# Conceptual Review Agenda

# Old Town North Mixed-Use

**Re:** Old Town North - Mixed-Use

**Description of project:** This is a request for a Major Amendment and Replat for the existing but undeveloped M Lots (30 single family attached lots divided among six 4-plexes and one 6-plex) and the corresponding G Lots (30 garages) on the east side of Jerome Street. Instead of single family attached dwellings, the proposal would consist of seven mixed-use buildings each featuring non-residential uses on the first floor and multi-family dwellings on the upper floors. The number of stories and height of the buildings and unit count is unknown at this time. The maximum allowable height is five stories. All parcels are located in the Community Commercial - North College (CCN) zone district. The Major Amendment and Replat will be processed in the same manner as the original plan - Planning and Zoning Board (Type Two) review.

Lots M31-M34 sample affects on lots

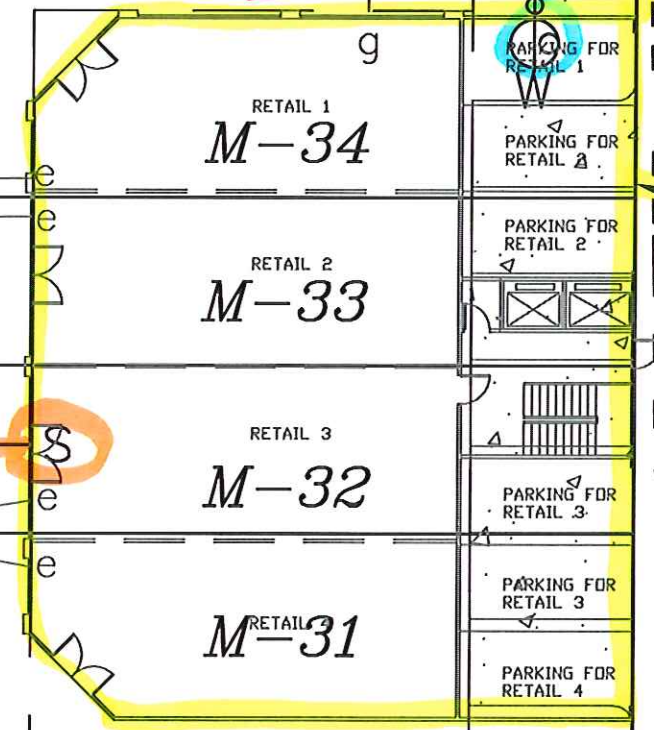
2. There are existing water and sewer services to each block of the proposed development that must either be used or disconnected at the main. It is not apparent what size these services are from the Old Town North plans so this will need to be verified by the applicant or applicant's contractor to determine adequate water supply to the proposed buildings.

3. Separate service lines will be needed for each of the buildings and each building will need separate services for the commercial and residential portions of the building. Additional services may be needed in order to satisfy this requirement.

**1 ENLARGED SITE PLAN**  
 SCALE: 1" = 15'-0"  
 7.5' 0 15' 30' 45'  
 SCALE: 1" = 15'-0"

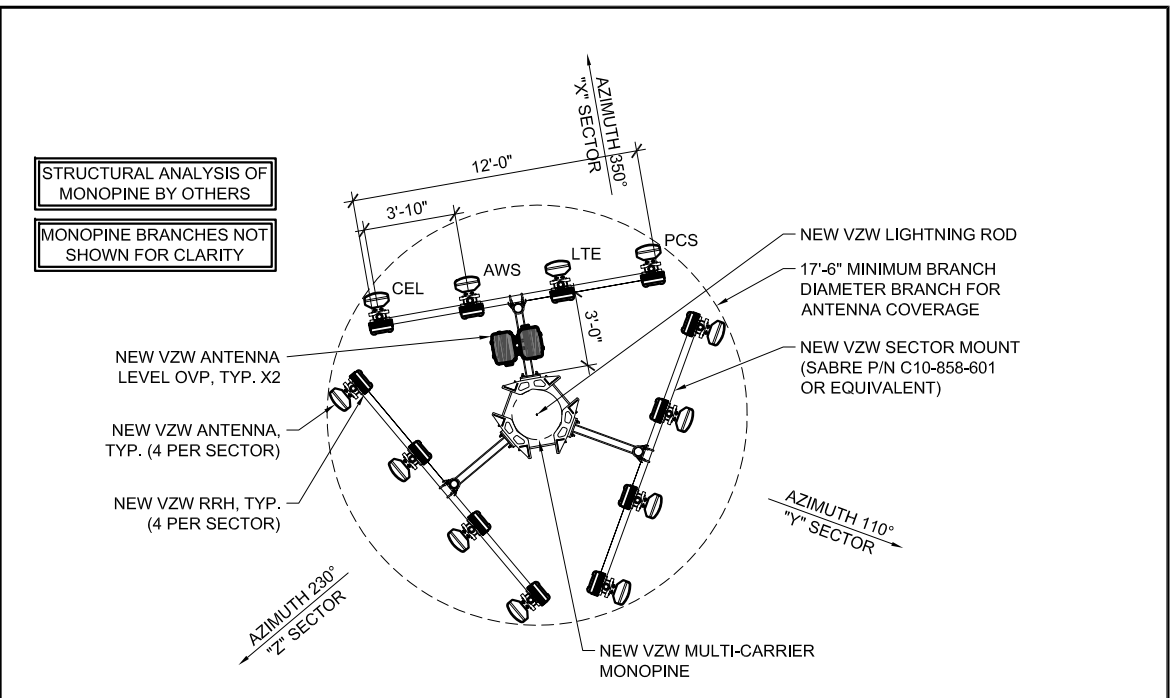
1. A combination of high-quality, durable fencing and landscaping should be used to achieve total screening of the base equipment, including the VZW equipment shelter. Since the shelter is approximately 8-feet tall, an 8-foot fence would be preferred to provide adequate screening. This would require a Modification of Standard Request for an exemption from the 6-foot fence height maximum. See LUC 3.8.13(C)(4) and (5).

**3 ANTENNA DETAIL**  
 SCALE: 1/4" = 1'-0"

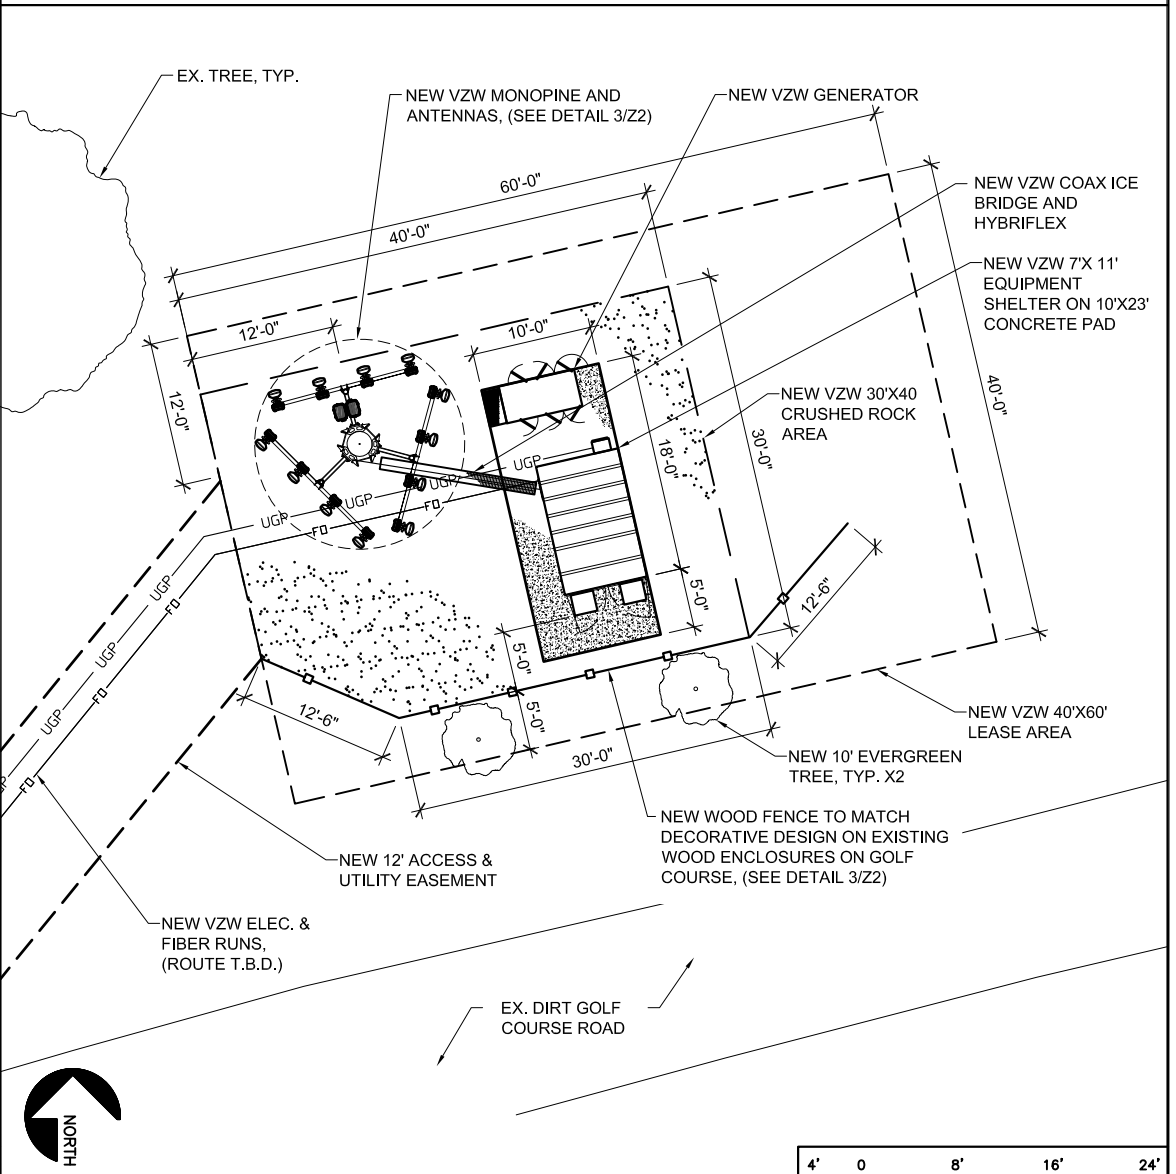
5. Consider native plant species similar to those existing on-site for the new 10-foot trees.
6. In your submittal, please provide a detail of the top portion of the antenna to ensure that the "branches" extend far enough to the sides to fully screen the equipment.
